UNITED STATES PATENT AND TRADEMARK OFFICE

APPLICATION NO.	FILING DATE	FIRST NAMED INVENTOR	ATTORNEY DOCKET NO.	CONFIRMATION NO.
10/809,032	03/25/2004	Michael C. Sefcik	25434-00077	5810

Office Action Summary	Application No.	Applicant(s)	
	10/809,032	SEFCIK ET AL.	
	Examiner	Art Unit	
	Rodney H. Bonck	3681

DETAILED ACTION

REPLACEMENT SHEET
APP. SERIAL NO. 10/809,032
SEFCIK ET AL.
25433-00175

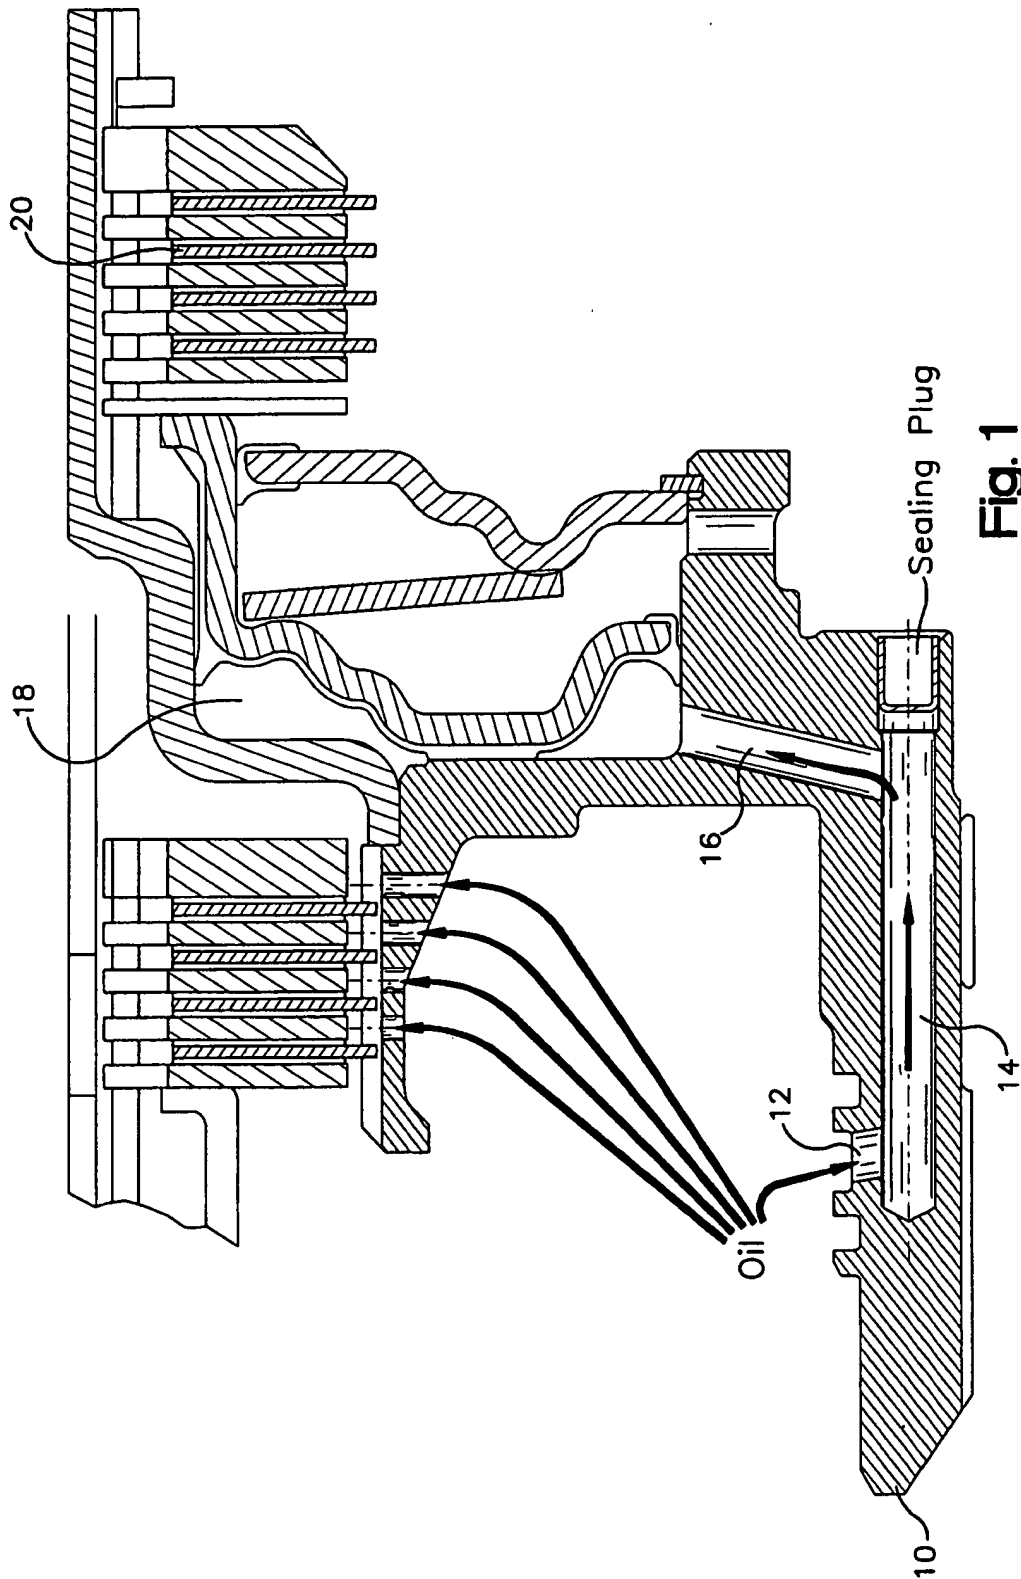
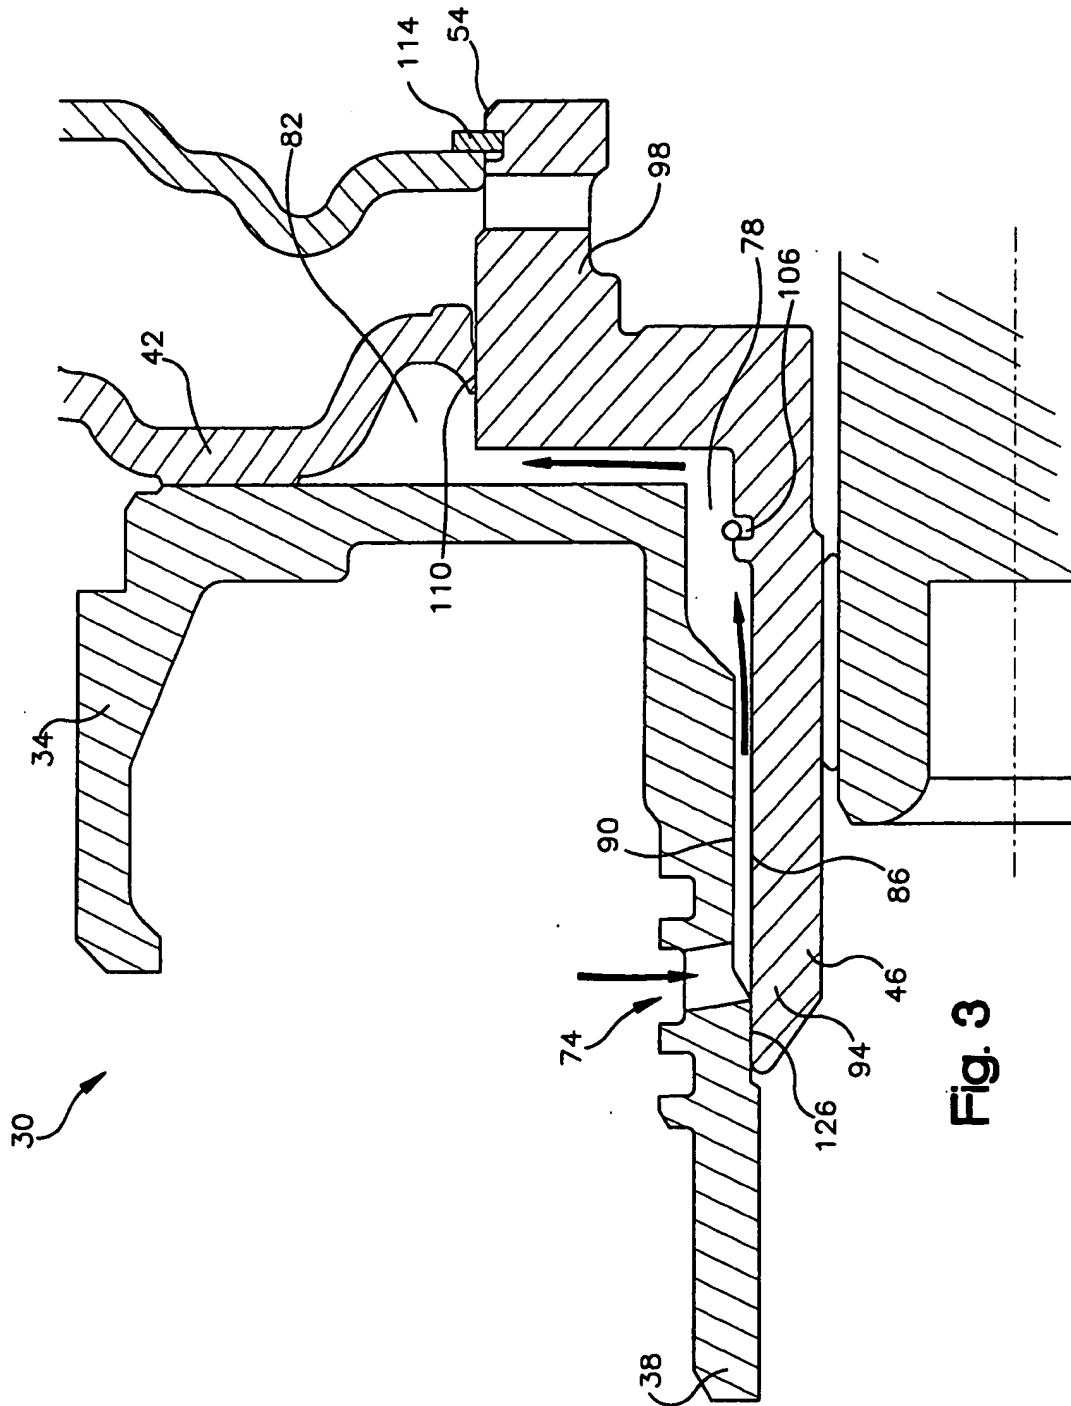
The replacement sheets of drawings were received on November 18, 2005. These drawings are acceptable. Accordingly, the objection to the drawings set forth in the previous Office action is withdrawn.

As noted above, the objection to the drawings has been overcome by the replacement drawings filed November 18, 2005, and the objection is withdrawn.
